**RE: Defect Information Report – Supplemental Report No. 3
11V-478, (11C-2, FL-613) EPA04 MBE 4000 Low Pressure Fuel Lines
Dealer Notice**

Subject: **Safety Recall 11C2**
EPA04 MBE 4000 Low Pressure Fuel Line

**18SP660Rev2 – EPA04 and EPA07 MBE 4000 Steel
Low Pressure Fuel Line Kits
(P/N: A4600702932 and
A4600703032)**

Figure 1 – Steel Low Pressure Fuel Line

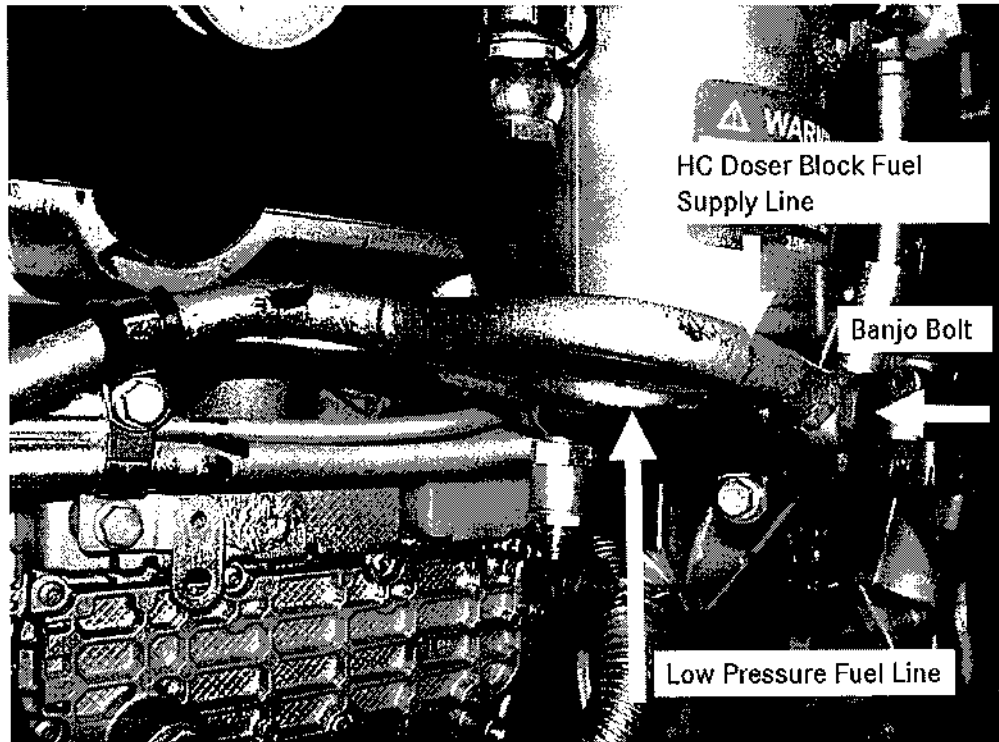
Detroit Diesel Corporation (DDC) has determined that some certified EPA04 MBE 4000 engines will require replacement of the low pressure fuel line with the latest design made from steel. There are approximately 70,830 engines involved, but some engines may have already been retrofitted with the new steel line and will not require any work. Replacing the low pressure fuel line will prevent fuel leaks that may result in customer dissatisfaction. In addition to installing the new parts, the fuel filter housing wall thickness will need to be inspected on EPA 04 engines within serial number range 0460878301 through 0460884090.

1. Apply the parking brake, chock the wheels, disconnect vehicle battery power, and perform any other applicable safety steps.
2. On the left side of the engine, **INSPECT** the low pressure fuel line that runs from fuel filter housing to the left front of the cylinder block. Reference Figure 1 for the location and appearance of the unpainted **NEW** steel fuel line.
 - a. If it is an unpainted **STEEL** line, then it does **NOT** need replacing and the fuel filter housing does **NOT** need to be inspected. Go to step 4.
 - b. If it is a **PLASTIC** line (painted or unpainted), then it **WILL** need to be replaced. Also, the fuel filter housing will need to be inspected on engine serial number range 0460878301 through 0460884090. Go to step 3.

3. **REFERENCE 18SP660Rev2** in the service kits for installation instructions on the new steel low pressure fuel line. New tool J-50161 Go/No-Go Gauge has been shipped to all DDC certified service locations for use in qualifying fuel filter housings on engine serial number range 0460878301 through 0460884090. The gauge has been supplied and shipped at no cost. **REFERENCE** attached tool letter 09 TL-10. If you no longer have tool J-50161, a replacement can be purchased at the repair shop expense.
4. Check the routing of the ECU harness in the engine compartment, and make sure it is not rubbing on any of the fuel lines. As needed, use double tie straps to separate the fuel line(s) from the harness.
5. Reconnect vehicle battery power, start the engine, and verify repairs.

Figure 5 **Low Pressure Fuel Line Hole**

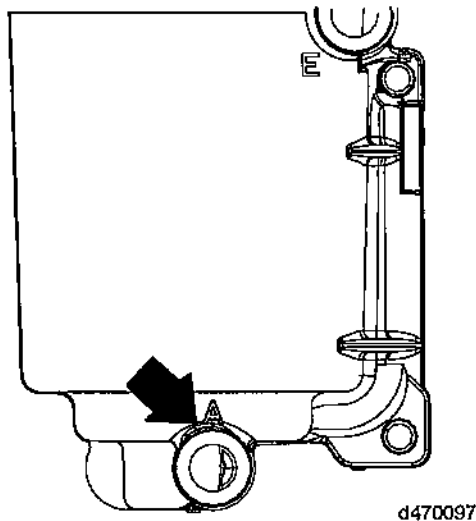
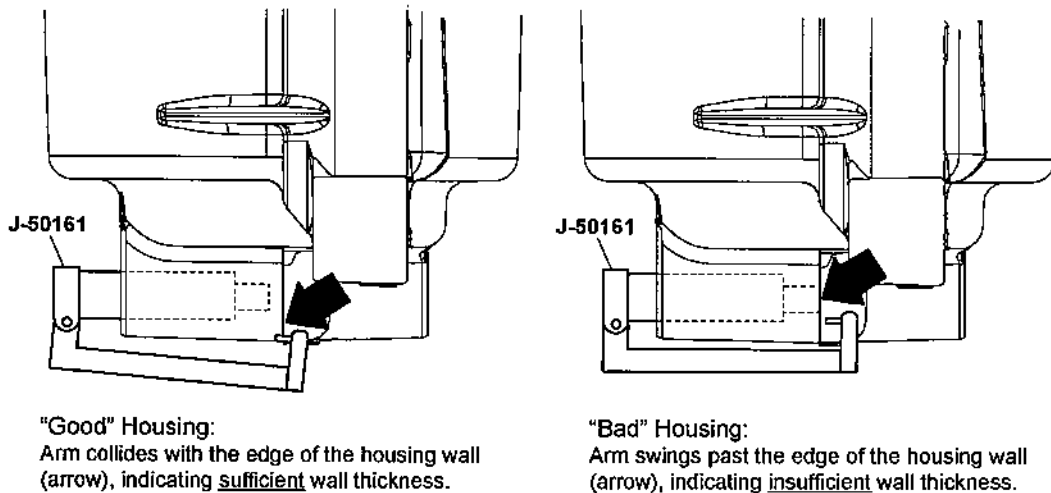
10. Engines equipped with a Hengst fuel filter housing with an EPA04 engine relative to recall 11C2, serial numbers between 0460878301 and 0460884090 or EPA07 engines relative to recall 09C2, serial numbers between 0460847011 and 0460888753 must have the fuel filter housing wall thickness inspected. Insert tool J-50161 into the hole in the fuel filter housing where the low pressure fuel line was removed, until it bottoms out.

On the Hengst housing, the low pressure fuel line bore is marked with a letter "A" for reference. See Figure 5.

11. Swing the tool arm up from the bottom to avoid interference with fuel lines. See Figure 6.
 - a. If the arm **DOES NOT** go past the end of the fuel filter housing, the housing has sufficient wall thickness.
 - b. If the arm **DOES** go past the end of the fuel filter housing and ends up parallel with the stationary body of the gauge, the housing does not have sufficient wall thickness and **MUST** be replaced.

Figure 7 Steel Fuel Line Installation (EPA07 Configuration)

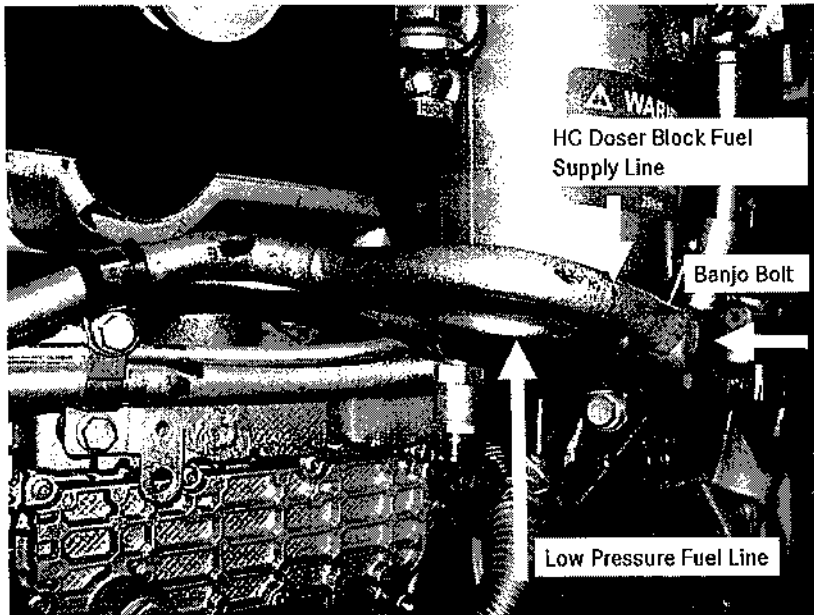
- b. For EPA07 configuration, use M16 x 46 banjo bolt (P/N: N915047012100) with three new seal rings (P/N: N000000001070), along with the hydrocarbon doser block fuel supply line. The new steel low pressure fuel line will be closest to the fuel filter housing. Do **NOT** bend either the steel low pressure fuel line or the hydrocarbon doser block fuel supply line. See Figure 7 for the correct installation of the lines.

4. Torque the banjo bolts to 40 N·m (30 lb·ft), starting with the banjo bolt at the front of the cylinder block.
5. Install fuel line clamps in their original positions. Clamps must go over foam covered areas of the fuel lines. See Figure 8.
